SUBSURFACE WASTEWATER DISPOSAL SYSTEM APPLICATION

Mike Adams
SEPTIC SYSTEM DESIGN

To: George Soucy
CC: file
From: Kane P. Coffin
Date: April 13, 2005
Re: Septic System Design for Mike Adams on Blair Road

Revised Septic System Design

SUBSURFACE WASTEWATER DISPOSAL PLAN

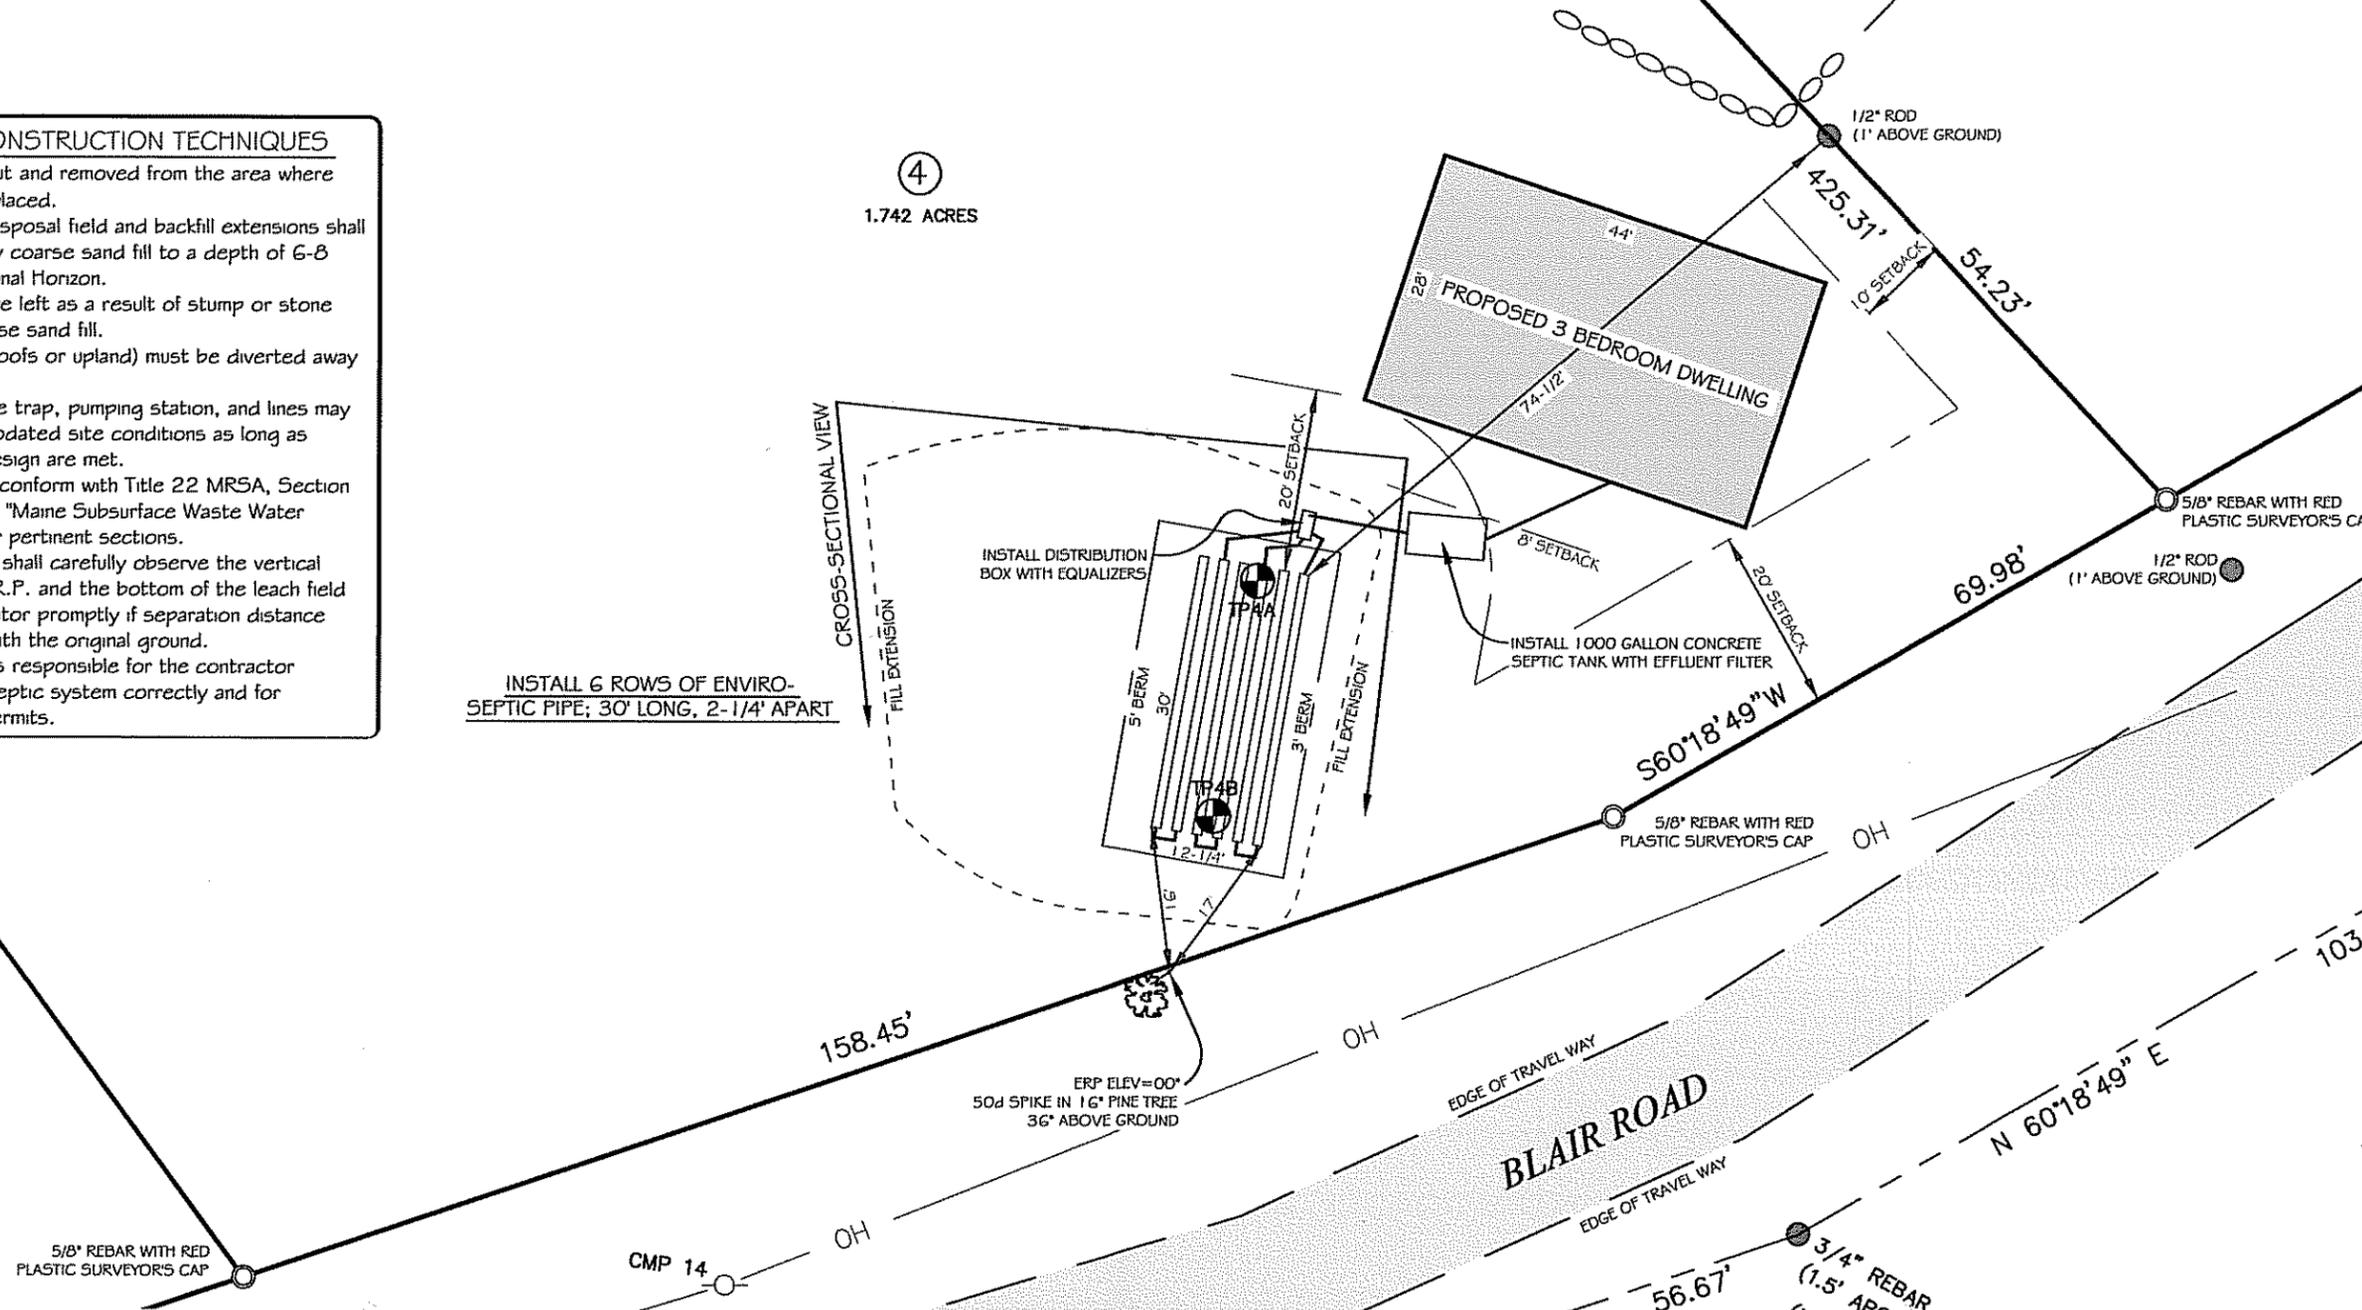
The septic system design for Mike Adams on Lot #4, Parlin Subdivision, dated January 5, 2005, has been revised to correct the improper installation by Mark Walker. The original design was for 6 rows of 30 feet long enviro-septic pipe, spaced 2.25 feet (2'-3") apart center-to-center. Mark Walker installed the pipe at 2'-1/4" apart center-to-center.

An additional pipe was installed at 2.25 feet center-to-center, now making the leach field 7 rows of 30 long enviro-septic pipe, which more than compensates for the inadequate spacing for the first six rows
